Re: Formal Request for Written Determination on Access, Emergency Egress, and Sewer Capacity — Grupe Investment Company / 8100 Valentine Avenue Housing Project (“Valentine Avenue Homes”)

RE: Public Hearing Opposition – 8100 Valentine Avenue
Tentative Subdivision Map, Density Bonus, and Tree Removal Permits (Rob Toste / The Grupe Company, LLC)

Questions for the Sebastopol Tree Board

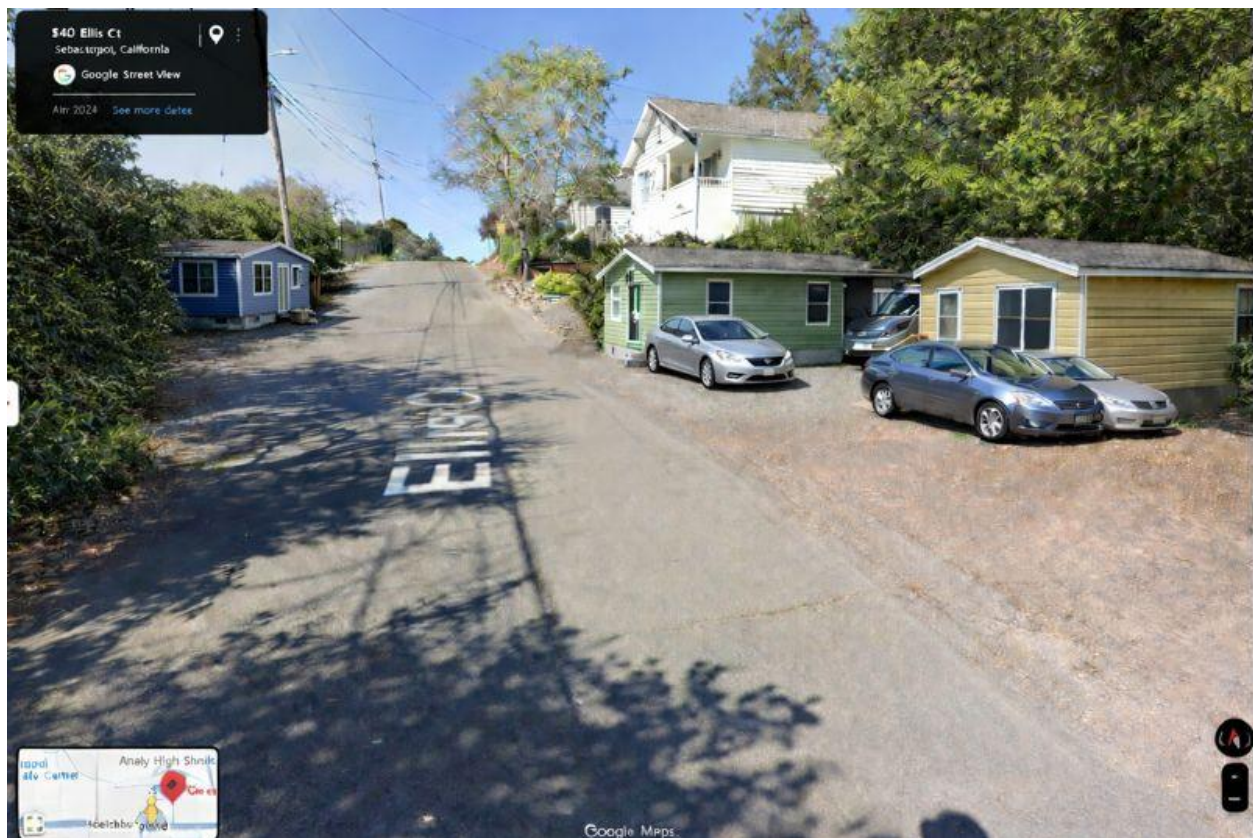
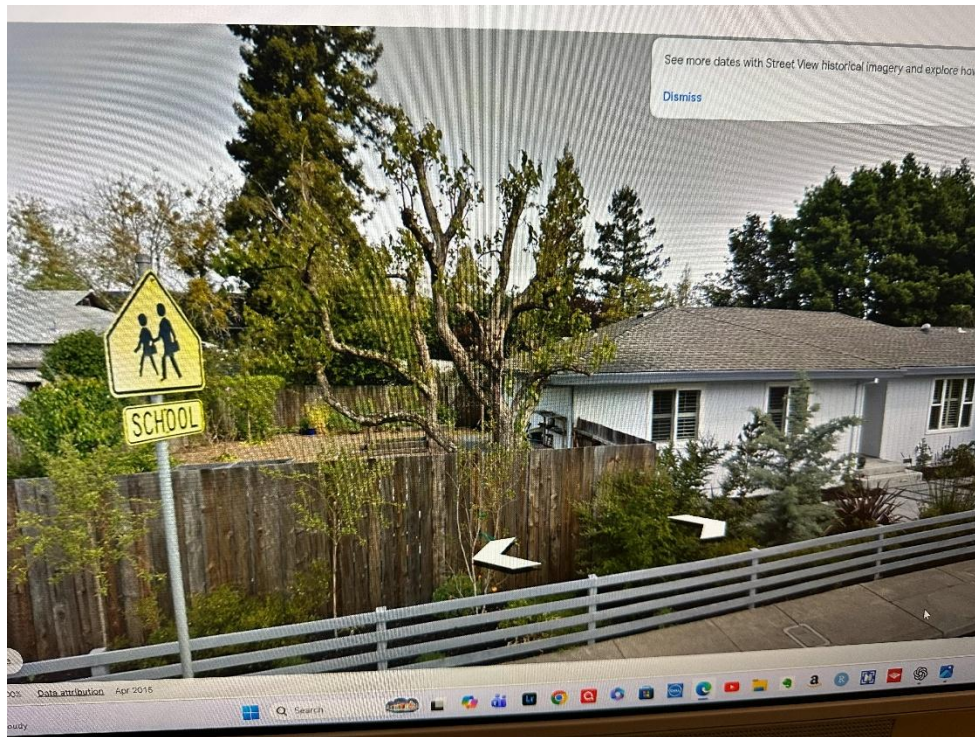
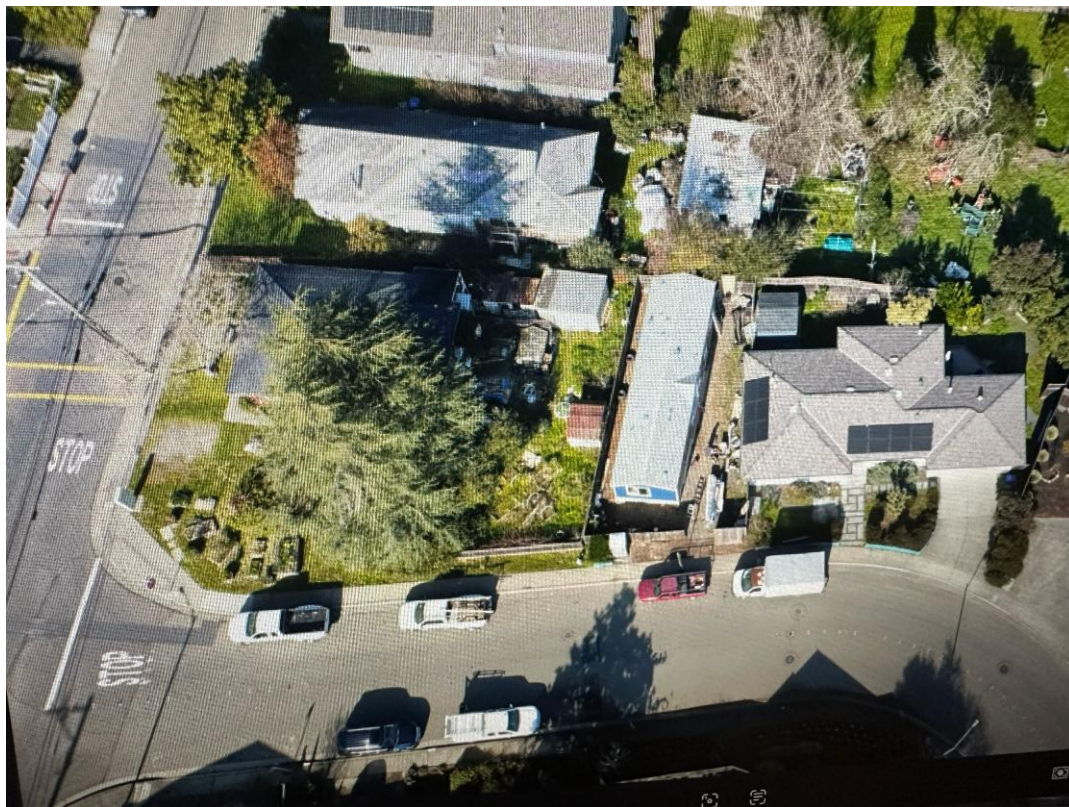
Below is an attempt to show how ADUs can affect the character of a street. Essentially no front setback and no requirement the ADU meet any objective design requirements that make them fit better into the character of the neighborhood. This is not hypothetical. Also below are before and after for a Sebastopol resident that literally took out a large tree and garden and dropped a mobile home in the backyard.

APN 004-510-054

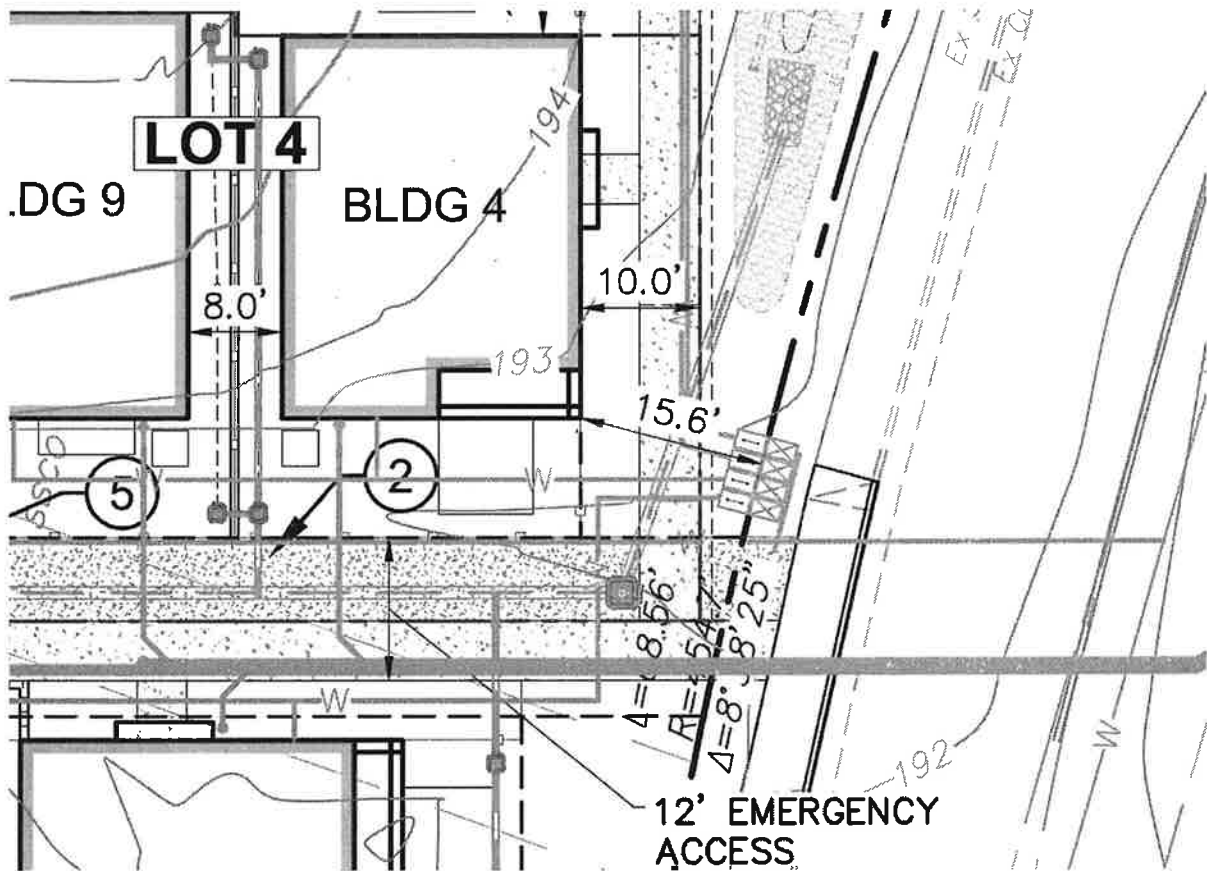
Length and access determination. Based on my own scaled measurement of Sheet C2.0 of the Vesting Tentative Map — using the plan’s stated graphic scale of 1” = 20’ — the Project’s main driveway appears to run approximately 550 to 575 feet from the

Valentine Avenue curb cut to the fire apparatus turnaround (“FSS Turnaround”) at the north-west end of the site, which is at or above the 500-foot threshold in SMC 16.40.040. Please confirm the exact length of this internal street network from its intersection with Valentine Avenue — using your office’s own engineered plans and centerline stationing rather than a scaled estimate — and provide a written determination as to whether SMC 16.40.040 requires the Project to provide multiple access given that length.

Evaluation of the secondary route. Please provide a written evaluation of the proposed secondary/emergency access path against the ordinance’s “reasonable ingress and egress for emergency vehicles” standard, specifically addressing: (a) whether the surface is paved or all-weather; (b) whether it meets Fire Code apparatus access requirements for width, turning radius, and load capacity; and (c) whether its location within or adjacent to shared recreational open space creates a foreseeable risk of obstruction during an emergency (e.g., parked vehicles, gatherings, temporary structures, or gating).

- Sheet C2.0 of the Vesting Tentative Map shows Lot 13 / Building 25 as the only unit in the entire 39-home project not paired with an ADU. The plan draws that building's own footprint directly over the trunk location of tag t28 (tree #128), a 34-inch protected redwood — which is listed on the same sheet's "Protected Trees to Be Removed" schedule. A second protected redwood, tag t30 (#130), is marked for removal just a few feet off Building 25's corner.
- Will the Tree Board ask the applicant to evaluate eliminating or relocating Building 25 — the project's lowest-yield, non-ADU unit — as a project alternative that could retain tree #128 (and possibly #130), before approving removal of these protected trees?
